1906 20TH AVE S
SDCI #3037697-LU
Design Review Board Recommendation Meeting
June 28, 2022

EDG RESPONSE

Residential Entry

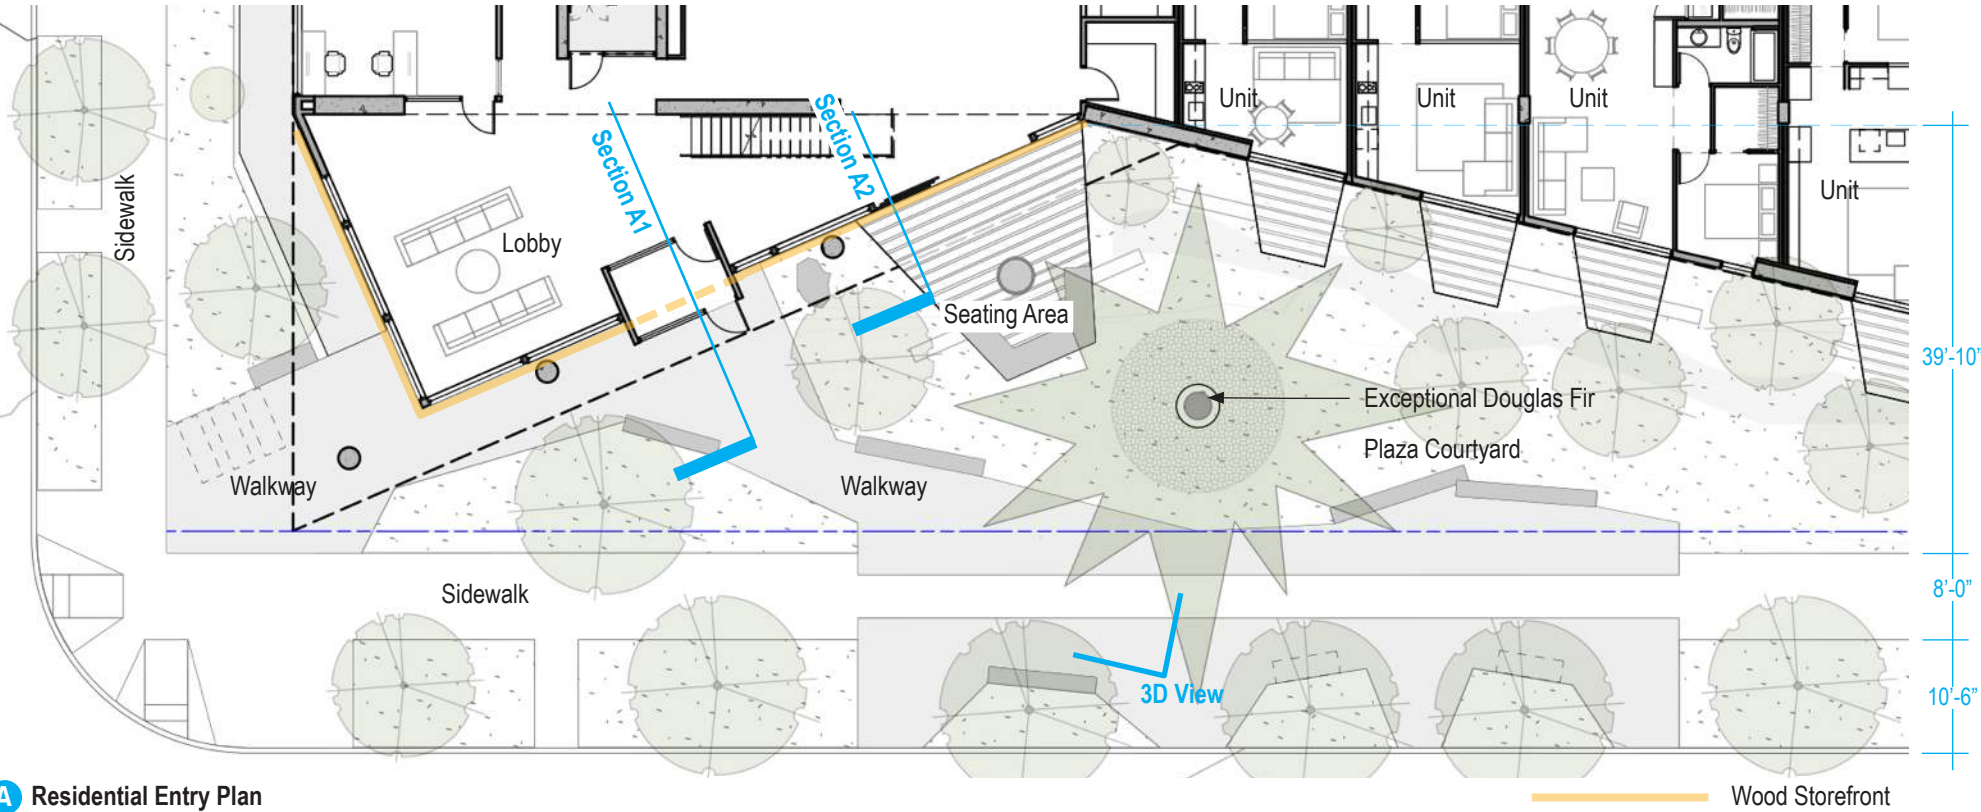
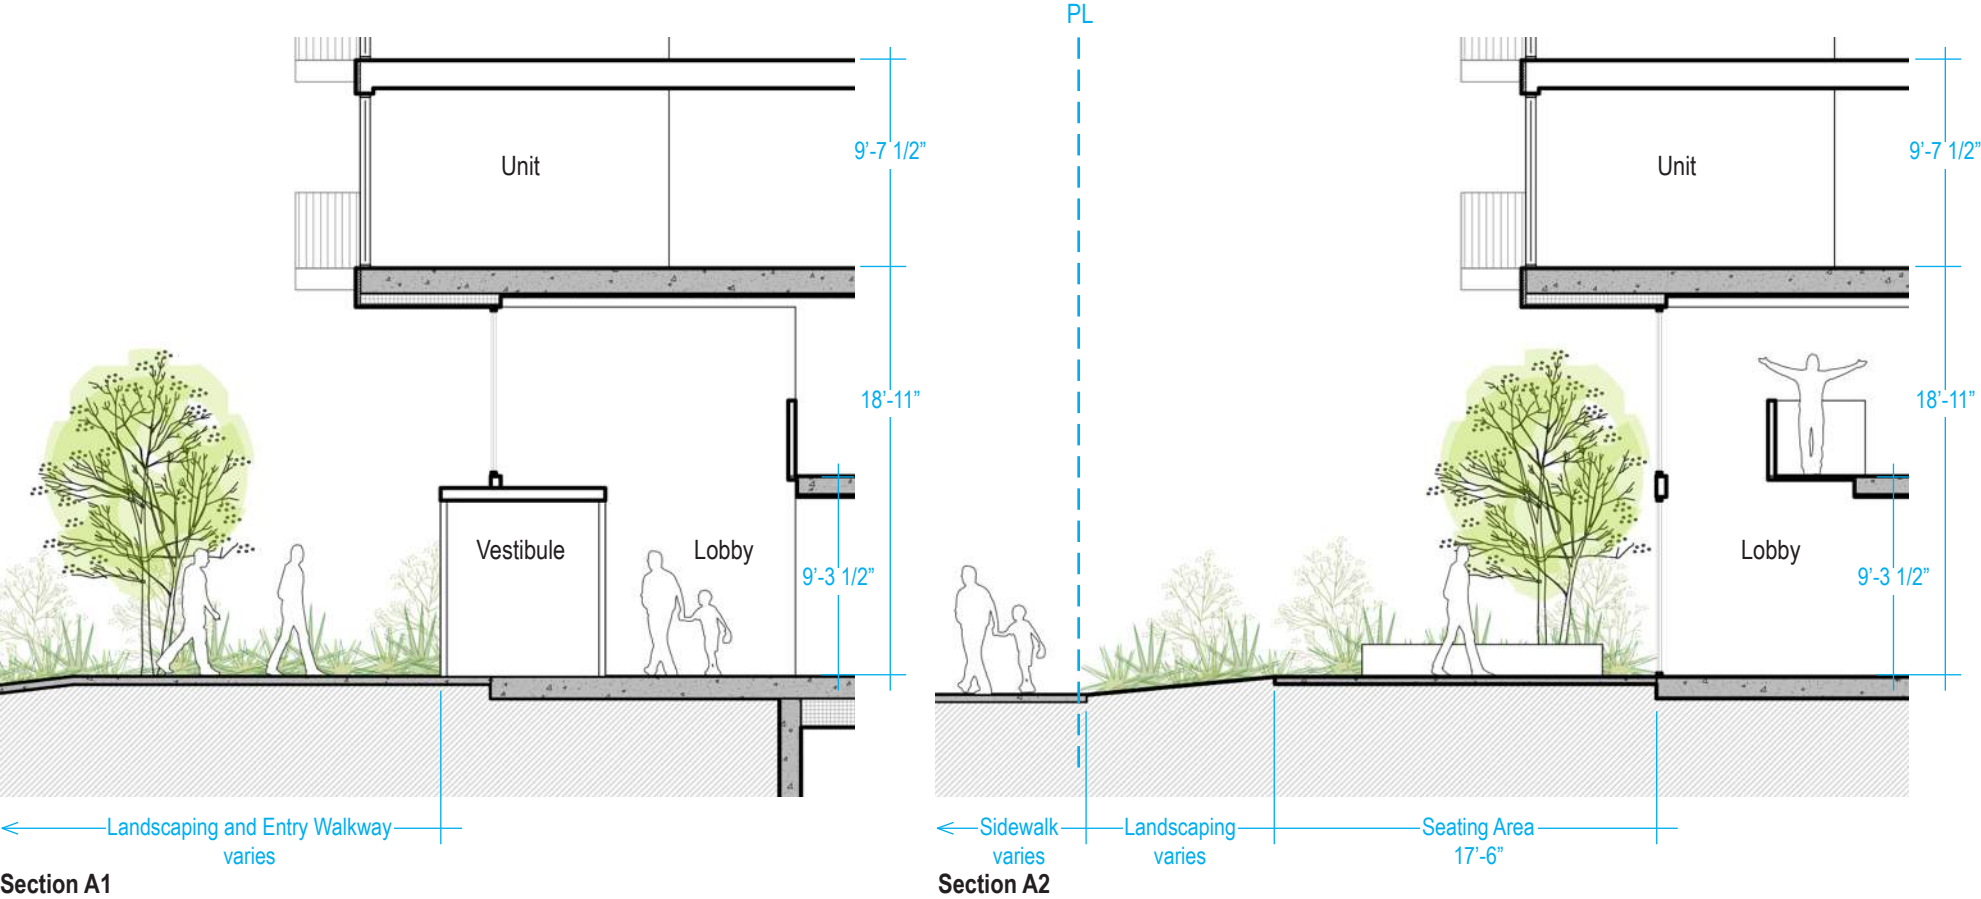
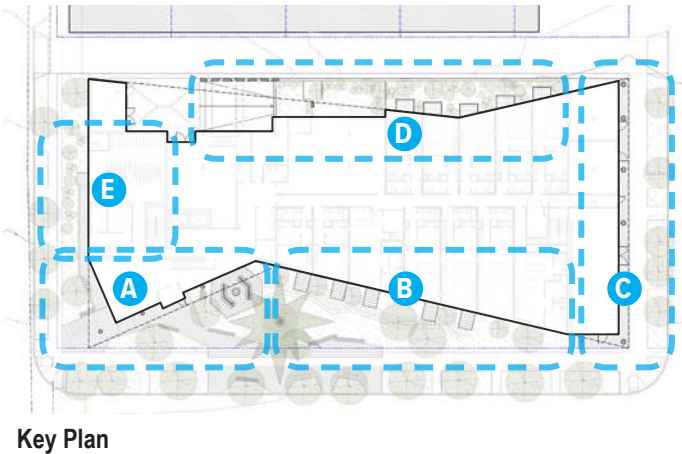
- 2a. The Board supported residential expression along the west façade where the project faces a residential zone and commercial expression along the north and south street frontages where ground-level commercial spaces are currently proposed. The Board requested examination at the Recommendation phase of review to show *how the distinct residential and commercial scales are expressed within the building design through materials and secondary architectural features* (PL2-D-1. Design as Wayfinding, DC2-C-1. Visual Depth and Interest, DC2-D-1. Human Scale, DC2-E-1. Legibility and Flexibility).

- 2b. Related to the guidance above for the design of ground-level uses, the Board requested ground-level perspective drawings along the street frontages to show the character of street frontages, the building design relationship to wayfinding, and the *relationships of ground-floor uses to each other and the street frontage* (PL2-D-1. Design as Wayfinding, PL3-C-1. Porous Edge, DC1-A. Arrangement of Interior Uses, DC2-D-1. Human Scale).

- 2a. The residential portions of the building are proposed have a distinctly different facade treatments and scales, in contrast to the commercial portion of the building. See plans, sections, and ground level renderings showing the different street level uses in this project. **A** Residential Entry **B** Residential Units **C** Commercial Spaces **D** Alley and **E** Bike Entry.

- The residential entry has been designed as a double height wood storefront that encloses a generous lobby space with a mezzanine. Staggered glass panels on the facade provide a backdrop to the entry vestibule portal and a landscape seating feature.

- 2b. Each of the ground level uses in this project will have a different character and relationship to the street. The plaza courtyard created around the Douglas Fir provides a privacy buffer from the ground floor residential uses and the primary building entry is expressed as double height space close to the edge of the property. Refer to the street level use plan and section diagrams for the **A** Residential Entry **B** Residential Units **C** Commercial Spaces **D** Alley and **E** Bike Entry.

Refer to the rendering at right showing the entrance path and facade treatment of the residential lobby.

Residential Units on 20th

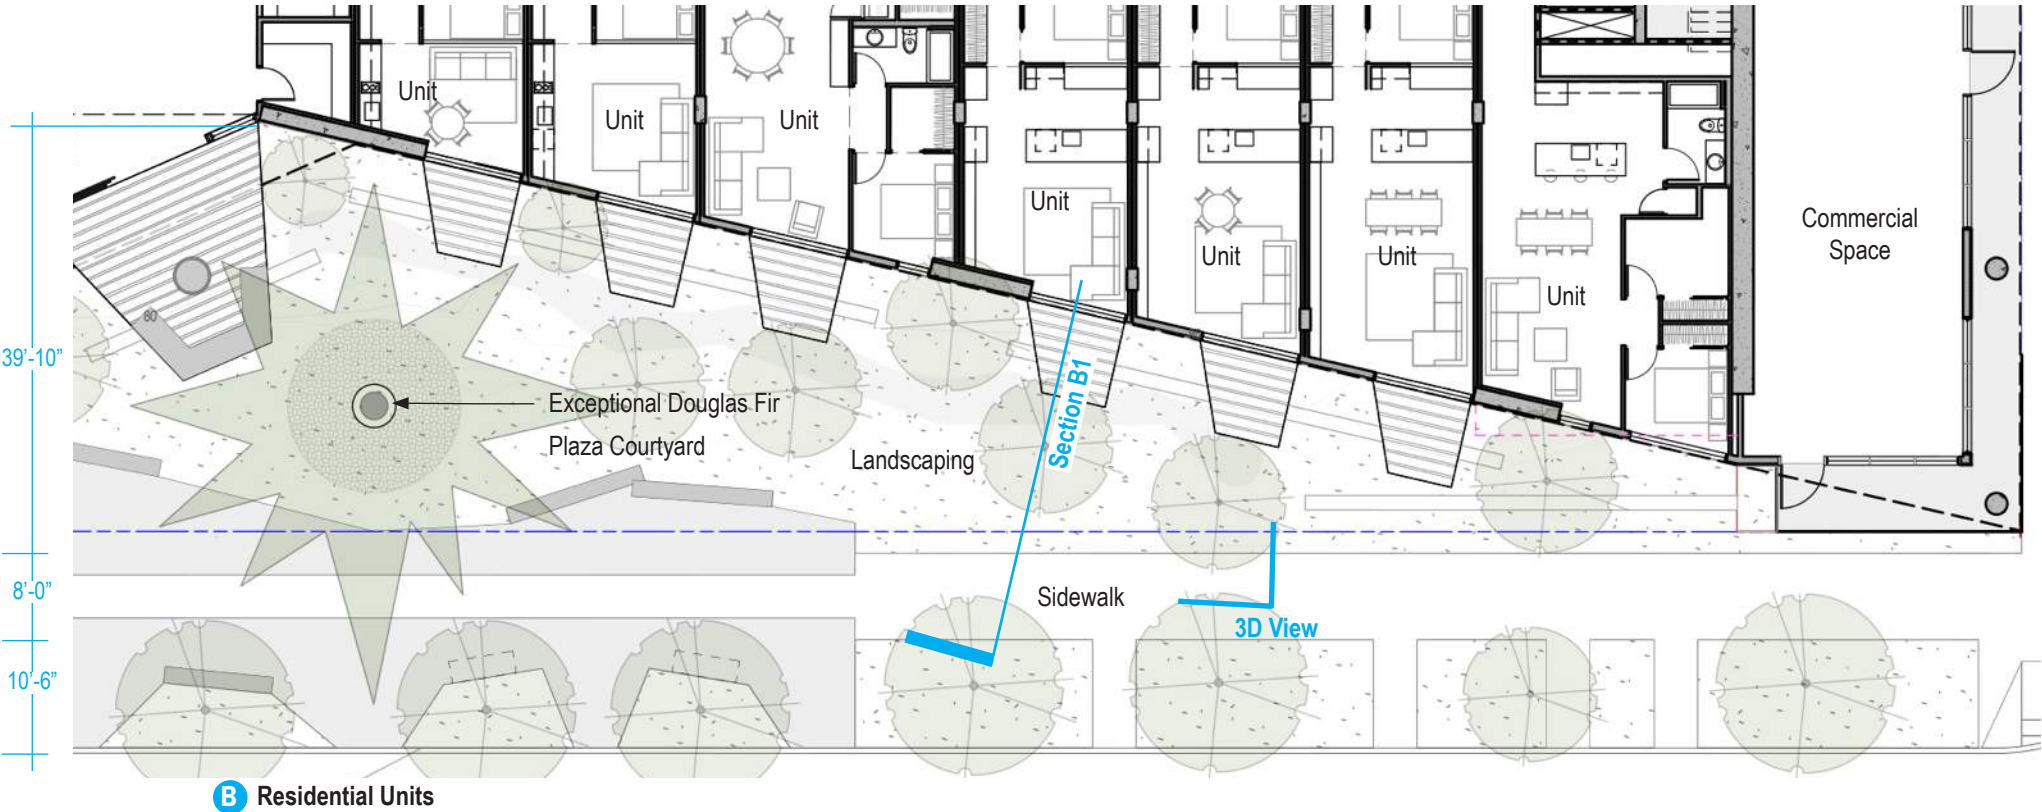
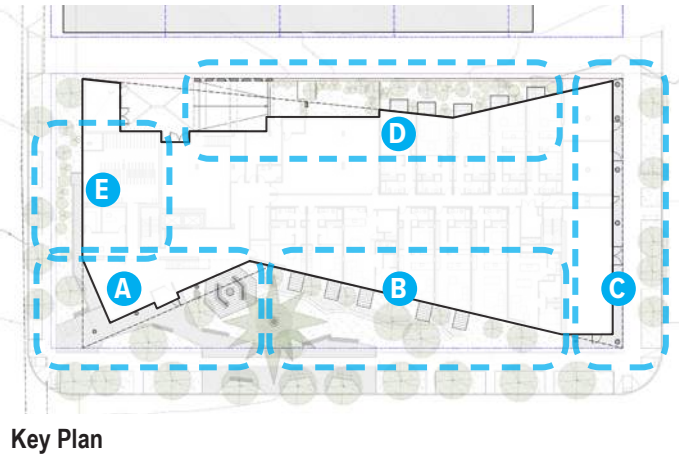
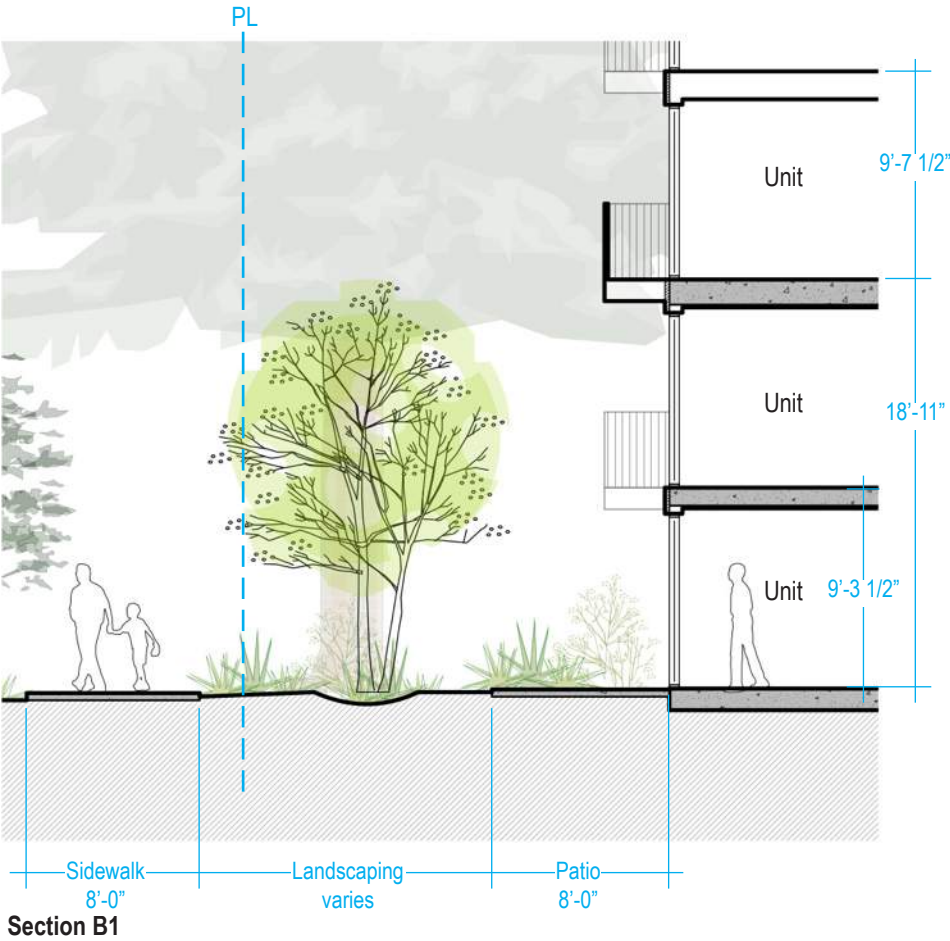
- 2a. The Board supported residential expression along the west façade where the project faces a residential zone and commercial expression along the north and south street frontages where ground-level commercial spaces are currently proposed. The Board requested examination at the Recommendation phase of review to show how the distinct residential and commercial scales are expressed within the building design through materials and secondary architectural features (PL2-D-1. Design as Wayfinding, DC2-C-1. Visual Depth and Interest, DC2-D-1. Human Scale, DC2-E-1. Legibility and Flexibility).

- 2b. Related to the guidance above for the design of ground-level uses, the Board requested ground-level perspective drawings along the street frontages to show the character of street frontages, the building design relationship to wayfinding, and the relationships of ground-floor uses to each other and the street frontage (PL2-D-1. Design as Wayfinding, PL3-C-1. Porous Edge, DC1-A. Arrangement of Interior Uses, DC2-D-1. Human Scale).

- 2a. In contrast to the primary building entry and commercial portion, the residential portion has a distinctly different facade treatment and scale. See plans, sections, and ground level renderings showing the different street level uses in this project. A Residential Entry B Residential Units C Commercial Spaces D Alley and E Bike Entry.

- The residential units at grade have a facade character similar to the units above. The units are single story and have semi- private exterior patios set back from the sidewalk on 20th Ave. The patios are integrated into the bio-infiltration landscaping helping to provide some privacy while mitigating storm water.

- 2b. Each of the ground level uses in this project will have a different character and relationship to the street. The plaza courtyard created around the Douglas Fir provides a privacy buffer from the ground floor residential use and the primary building entry is expressed as double height space close to the edge of the property. Refer to the street level use plan and section diagrams for the A Residential Entry B Residential Units C Commercial Spaces D Alley and E Bike Entry.

Refer to the rendering at right showing the facade treatment and landscaping at the residential units.
